RE: **Lot 6 Block 1 Unit 22 SAD 228
8019 Alto Rey NW
Volcano Cliffs Subdivision
Grading and Drainage Plan
Engineers Stamp Date 7/23/2020 (D10D003N6)**

Based upon the information provided in your submittal received 7/27/2020, this plan is approved for Grading Permit.

ENGINEER'S SEAL		LOT 6 BLK 1 UN 22 VC 8019 ALTO REY CT.	DRAWN BY DEM
			DATE 7-23-20
7/23/20		GRADING AND DRAINAGE PLAN	LOT XX BLK 1 UN 22 VC DWS
			SHEET # C1
DAVID SOULE P.E. #14522		1808 CENTRAL AVENUE SE SUITE 201 ALBUQUERQUE, NM 87106 (505) 872-0999	JOB # _____

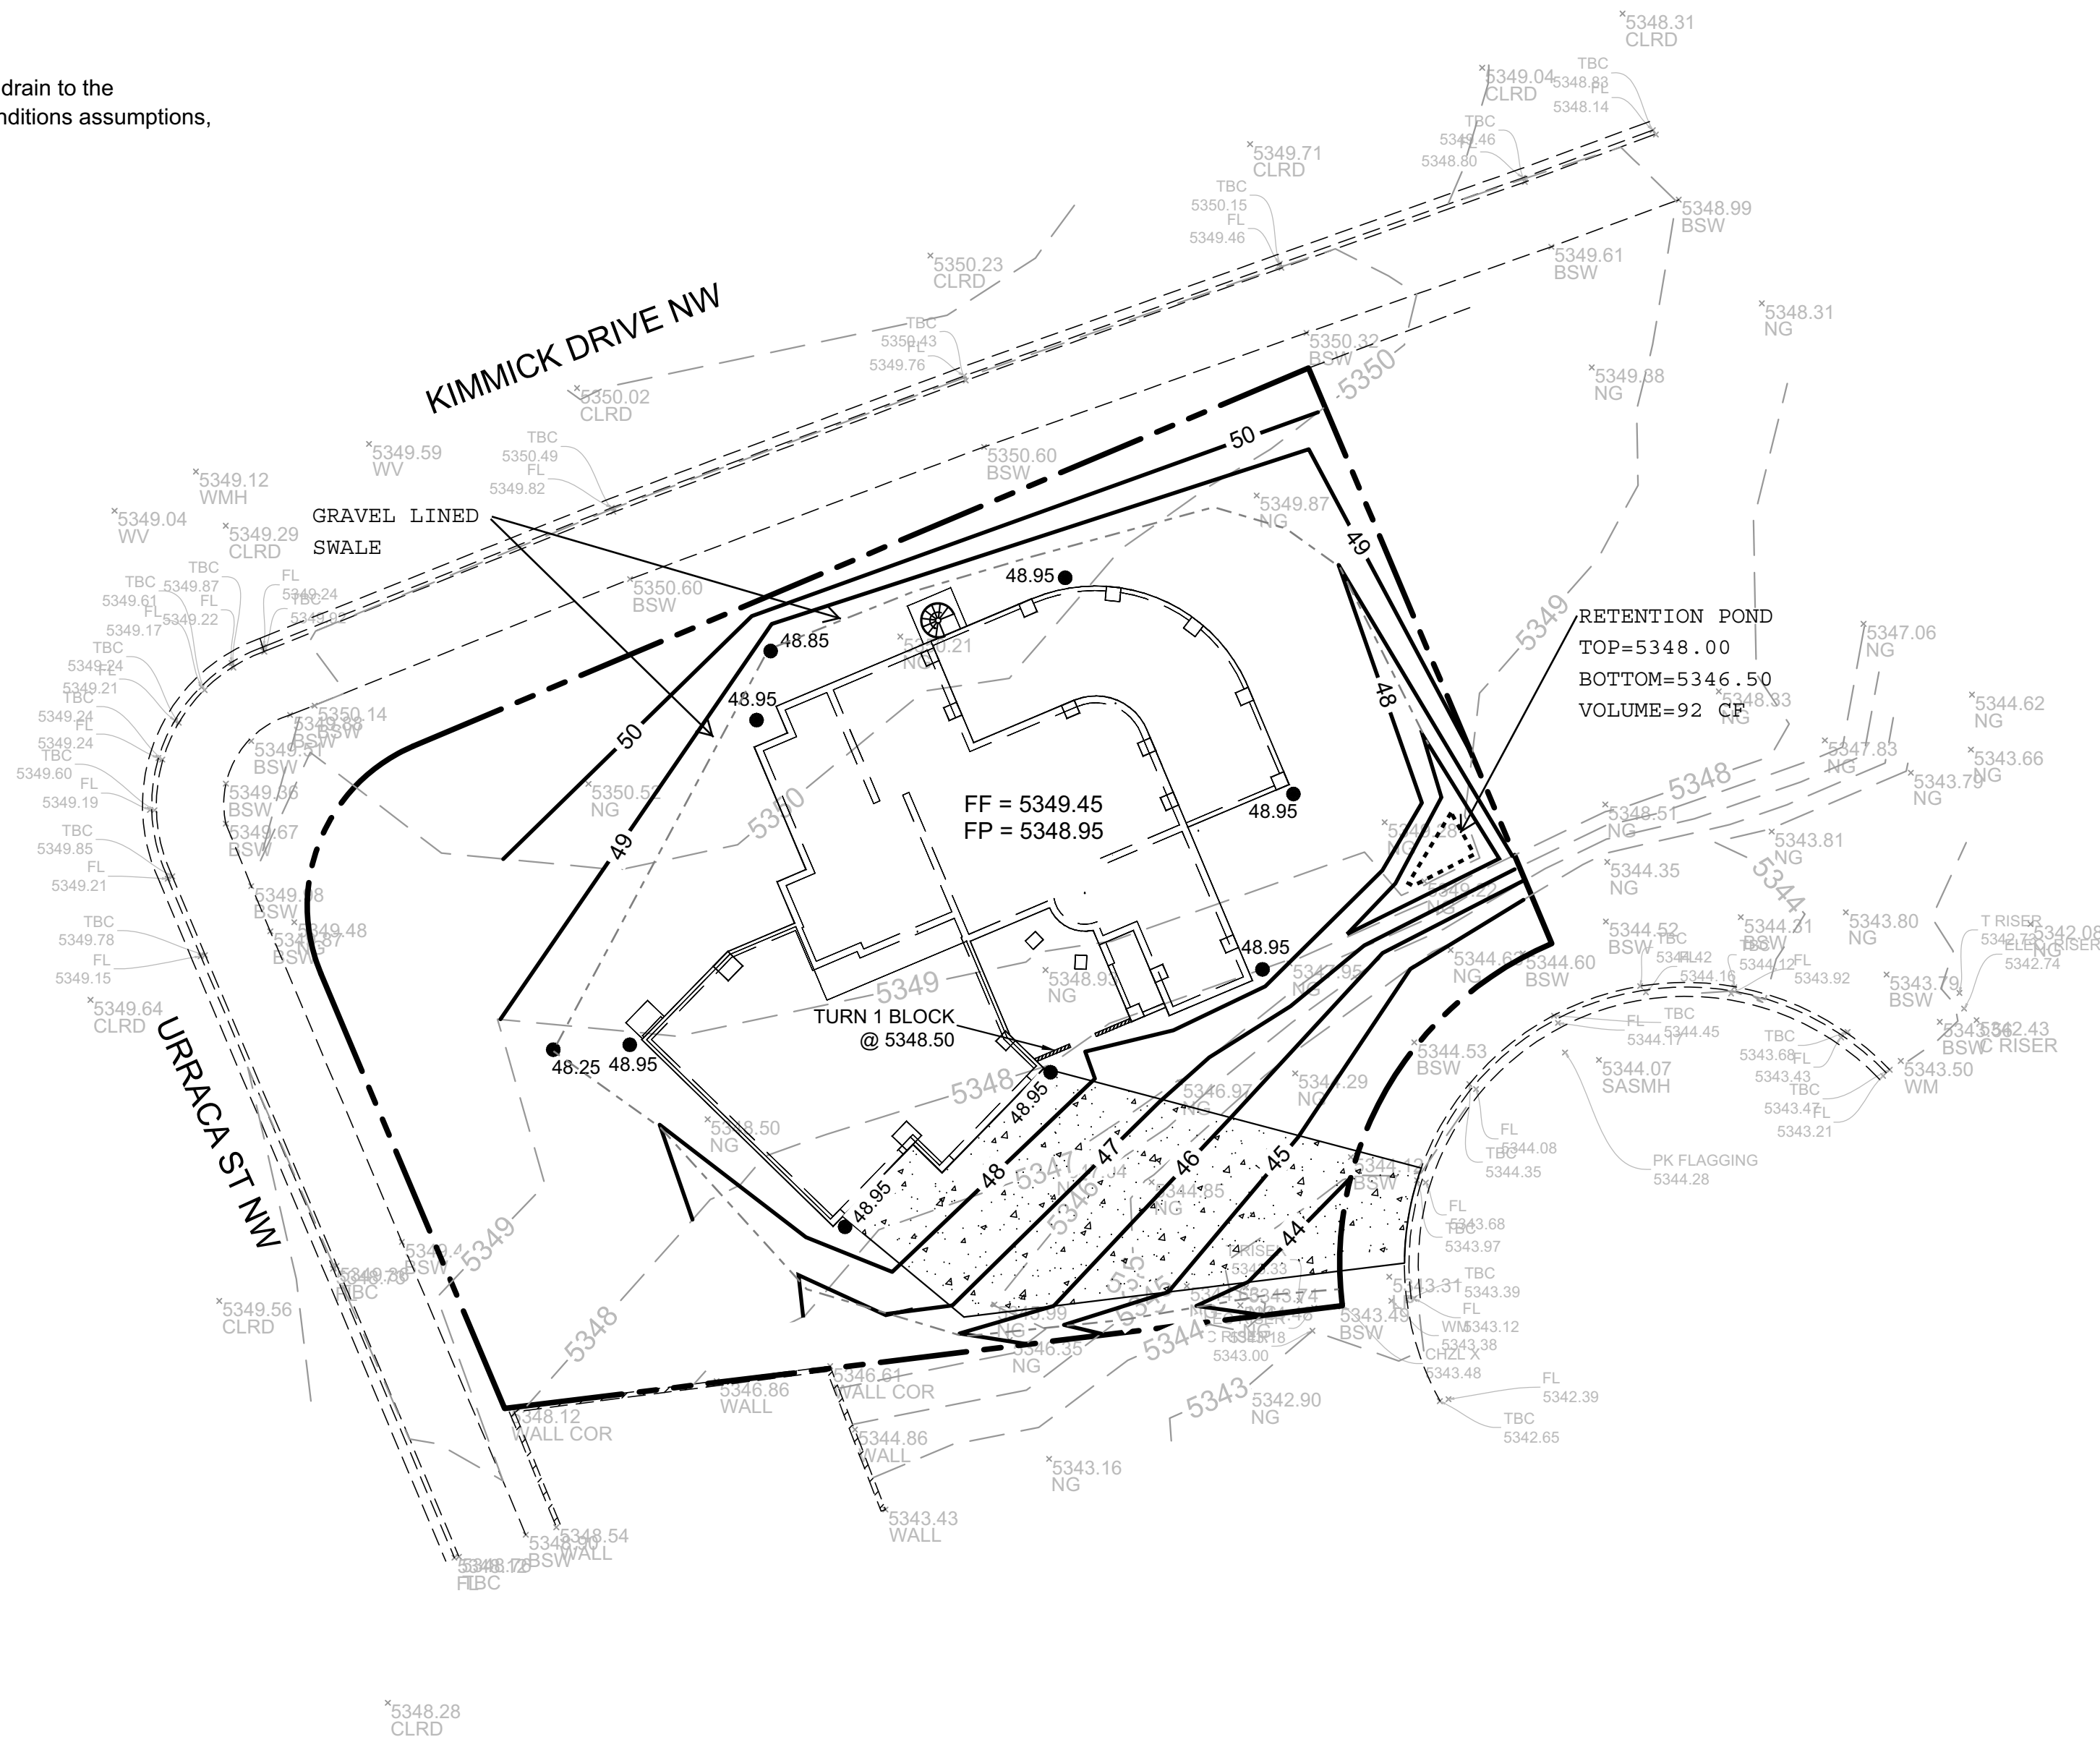
Prior to Building permit approval a Pad Certification will be required, provided by the Engineer or a registered Land Surveyor.

Advise the owner contractor not to use dirt as a ramp to climb the curb, use lumber or crusher fines for this purpose.

Reiterate to the Owner/Contractor that a separate permit for a garden/retaining wall must be obtained with the approved G&D plan and Pad Certification. Also, if a swimming pool is to be placed the grading and drainage plan will change and will need to be resubmitted.

Prior to Certificate of Occupancy release, Engineer Certification per the DPM checklist is required.
